Project	<b>IEEE 802.16 Broadband Wireless Access Working Group</b> < <a href="http://ieee802.org/16">http://ieee802.org/16</a> >	
Title	<b>Obtaining Sleep Mode Information in RS</b>	
Date Submitted	<b>2006-11-16</b>	
Source(s)	<p>Yuefeng Zhou; Mike Hart; Sunil Vadgama Fujitsu Laboratories of Europe Ltd Hayes Park Central, Hayes End Road, Hayes, Middlesex, UB4 8FE, UK</p> <p>Shiao-Li Tsao, Fang-Ching Ren, Wern-Ho Sheen, I-Kang Fu National Chiao Tung University (NCTU) /Industrial Technology Research Institute (ITRI), Taiwan No. 195, Sec. 4, Chung Hsing Rd., Chutung, Hsinchu, Taiwan 310, R.O.C.</p>	<p>Voice: +44 (0) 20 8573 4444 FAX: +44 (0) 20 8606 4539 <a href="mailto:yuefeng.zhou@uk.fujitsu.com">yuefeng.zhou@uk.fujitsu.com</a> <a href="mailto:mike.hart@uk.fujitsu.com">mike.hart@uk.fujitsu.com</a> <a href="mailto:sunil.vadgama@uk.fujitsu.com">sunil.vadgama@uk.fujitsu.com</a></p> <p>Voice: +886-3-5712121-54717 Fax: +886-3-5721490 E-mail: <a href="mailto:sltsao@cs.nctu.edu.tw">sltsao@cs.nctu.edu.tw</a>;<a href="mailto:frank_ren@itri.org.tw">frank_ren@itri.org.tw</a></p>

# Obtaining Sleep Mode Information in RS

Fig. 1. RS decodes the MOB\_SLP\_RSP message for further scheduling

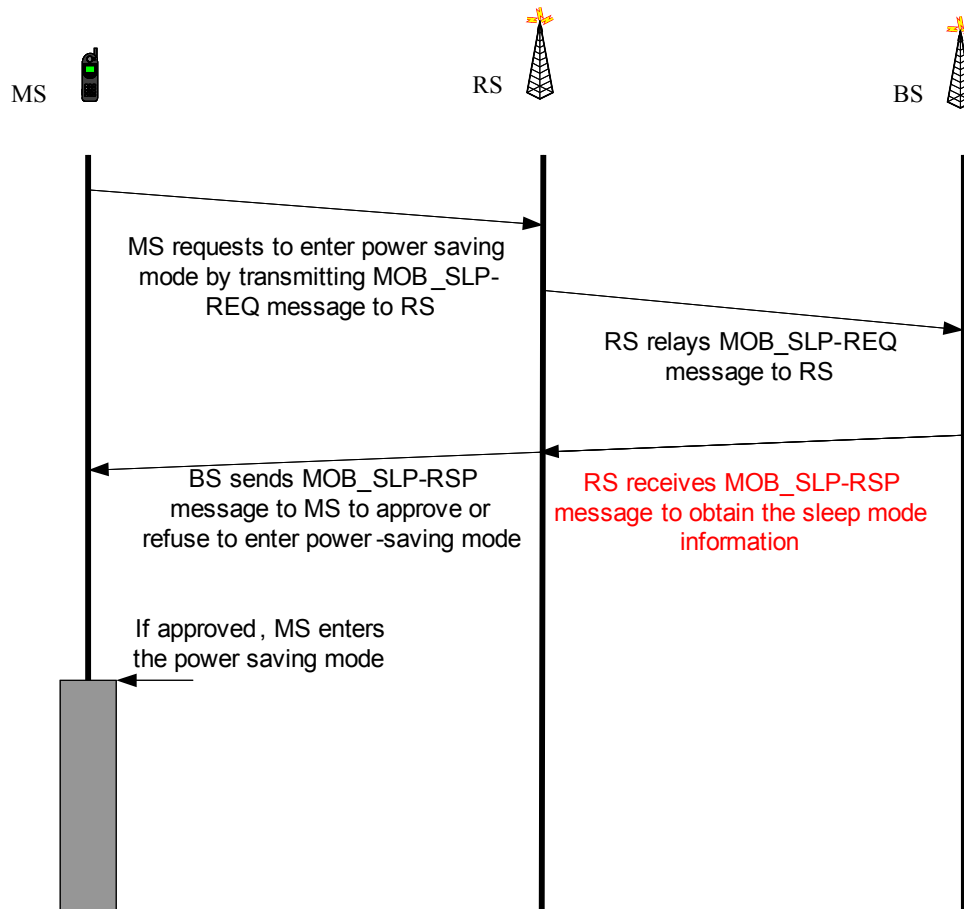
RS may have the capability to listen and decode the MOB\_SLP\_RSP message to obtain the sleep-mode information. For example, if the sleep mode is initialized by MS, as shown in Fig. 1, RS shall decode the MOB\_SLP\_RSP message sent by MR-BS to obtain enough timing information, thus it can allocate resources to MS on time for the event-based actions, also RS can avoid sending management messages to this MS, and can cancel the bandwidth allocated to MS during the sleep period.

In MR networks, the sleep mode is managed by MR-BS. MR-BS shall buffer the traffic addressed to a sleep-mode MS, thus saving buffering in RS.

In distributed case, RS may decode the relevant messages, such as MOB\_SLP-RSP, sent by MR-BS to obtain the timing and the event-based action information, thus RS can avoid sending management message to the sleep-mode MS, and schedule proper radio resource to the MS in sleep mode.
